# Mountain Valley Pipeline Project

## Individual Permit Application

Attachment C: Virginia Marine Resources Commission Permit  
Modification Request and Materials

February 2021

**Figure 3  
Craig Creek  
Crossing Location**

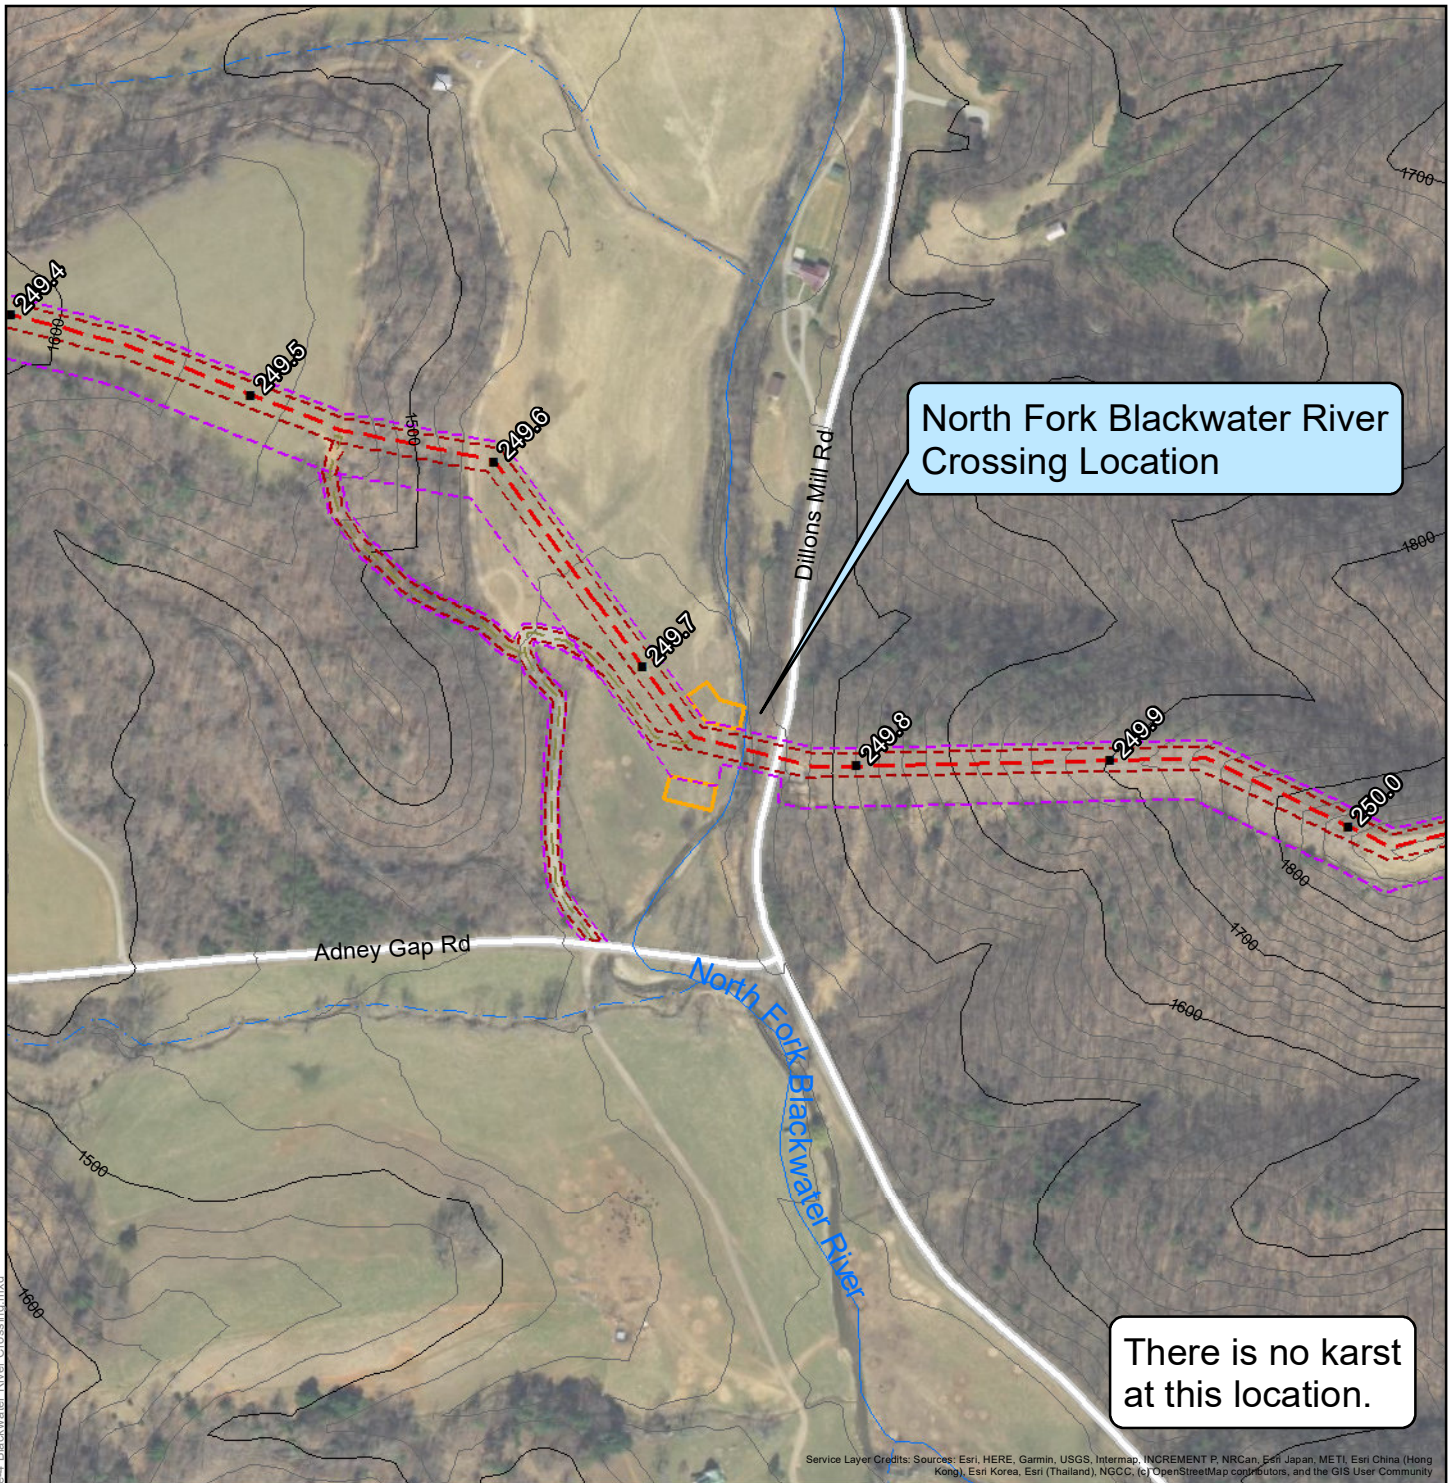
Mountain Valley is now preparing to revise the pending VMRC permit modification request to change the preferred crossing method for four additional VMRC-regulated crossings: Craig Creek (Montgomery County, Figure 3 attached), North Fork Blackwater River (Franklin County, Figure 4 attached), Harpen Creek (Pittsylvania County, Figure 5 attached), and Little Stony Creek (Giles County, Figure 6 attached). Similar to the crossings you reviewed before, the revised permit modification will seek to change the crossing method for these four additional streams from open-cut dry-ditch to conventional bore (auger bore/bore & jack). This modification in crossing method will avoid direct instream disturbance to these four surface water resources. The mitigation measures that will be employed for these four crossings are the same as discussed in the email below. Please note that the open-cut dry-ditch method will become the contingency method of construction in the unlikely event the conventional bore is unsuccessful.
